## PUBLIC UTILITIES COMMISSION

July 7, 2021

RE: Valley-Ivyglen 115kV Subtransmission Project (VIG) – Minor Project Refinement No. 15 Request: Notice to Proceed (NTP-) 1 and 2 Lake Street Excavation and Supplemental Work Areas at multiple locations throughout Segments VIG1-VIG7

Figure 1. Proposed Areas of Excavation (white polygons) Between 454E and 460E.

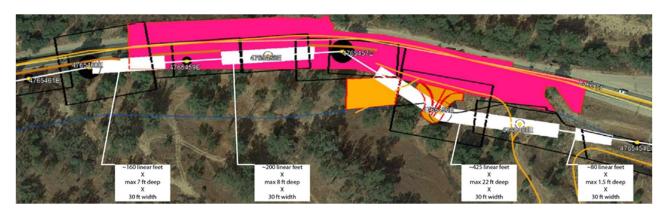
In coordination with the landowner and the City of Lake Elsinore, soil excavation is proposed between 454E and 460E to accommodate the future realignment of Lake Street. The planned Lake Street realignment will parallel the Valley-Ivyglen subtransmission line and will be constructed at an elevation similar to the existing Lake Street. The current ground elevation along the Valley-Ivyglen alignment is as much as 30 feet higher than the future elevation. In order to avoid future modifications to the Valley-Ivyglen line, the Project proposes to excavate soil at 455E, 456E, 458E, and 460E so the structures can be installed at the required future ground elevation. Additionally, where needed, the Project proposes to excavate 30-foot-wide swaths (Figure 1) underneath the path of the 115 kV conductor from 454E–460E to lower the ground elevation between structures and provide necessary ground clearance for the conductor and telecommunication wire. The depth of the excavations would vary as necessary to reach the future roadway elevation and would be as deep as 22 feet at 455E.

Portions of the proposed excavation from 454E–460E would be visible to drivers on Lake Street. Northbound drivers would see the deepest area of excavation at 455E, as well as the shallower excavations between 457E and 460E. Southbound drivers would see the excavations at 457E–460E, as well as a portion of the deeper excavation between 456E and 457E. The visual impact of the excavated areas would be mitigated through revegetation. The banks of the excavated areas would be sloped to facilitate restoration, and all excavated area would be revegetated in accordance with the Project SWPPPs, Project Commitment D and the VIG Habitat Restoration and Revegetation Plan. The realignment of Lake Street is expected to occur within the next two years, at which time the areas around the VIG line will be graded and landscaped by the developer.

Following the completion of all construction, the temporary work areas would be restored/reclaimed in accordance with the Project SWPPPs, Project Commitment D, and the VIG Habitat Restoration and Revegetation Plan. For excavations between 454E–460E, restoration would include grading final slope of no steeper than 3:1 and installing straw wattles along the slopes as required by the SWPPP.

Erosion would be controlled at locations of earth disturbance through the implementation and adherence to the Project linear SWPPP. The VIG LUP SWPPP would be amended to reflect the excavation activities and subsequent stabilization of soils from 454E to 460E. At the completion of construction, sites would be restored/reclaimed in accordance with the Project SWPPPs, Project Commitment D, and the VIG Habitat Restoration and Revegetation Plan. Restoration for excavated areas from 454E to 460E would include grading to a final slope of no steeper than 3:1 and installing straw wattles along the slopes at 6-foot spacing.

- 12. SCE will export cut material from the project site to a facility licensed/permitted to receive such material. Excess material placed at the project site area will be covered. SCE will expedite removal of the excess material from the project site area. Prior to material delivery SCE will notify the CPUC of the intended facility, and at the conclusion will provide CPUC with documentation of quantities of material delivered to the facility. During transport SCE will follow appropriate regulations, including SWPPP requirements regarding track-out, and covering any load to prevent dust, etc.
